Little Pine Creek II

Monitoring Year 3 of 7

Subject: Draft MY3 Monitoring Report Little Pine Creek II Mitigation Project, Alleghany County DMS ID No. 856 – DEQ Contract # LP082819

On December 7, 2022 Equinox was provided with comments on the MY3 Report for the Little Pine Creek II Site. Below are the original comments and Equinox responses (in RED).

Data used in this graphic was retrieved from NCSCO Station Sparta 2 Se (318158) located 6.2 miles WSW.

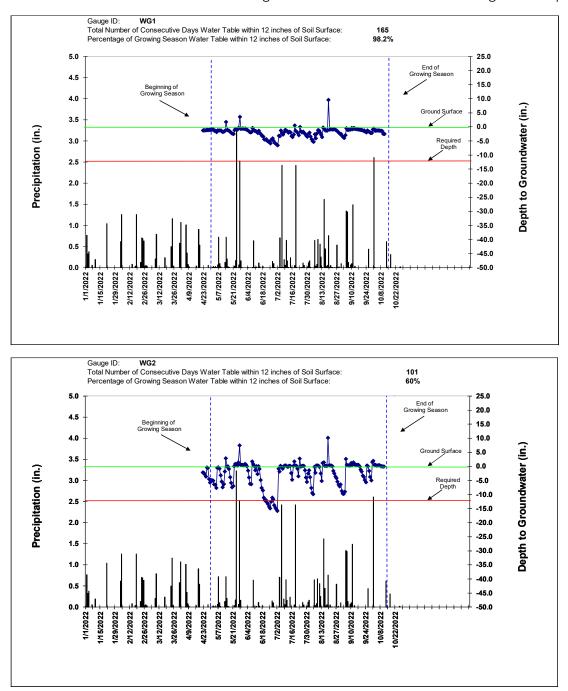
- Please add assessment dates for each visual assessment table. Dates added
- Please footnote sources below the rain and precipitation data tables (give approximate distance from the site for offsite). Footnote added
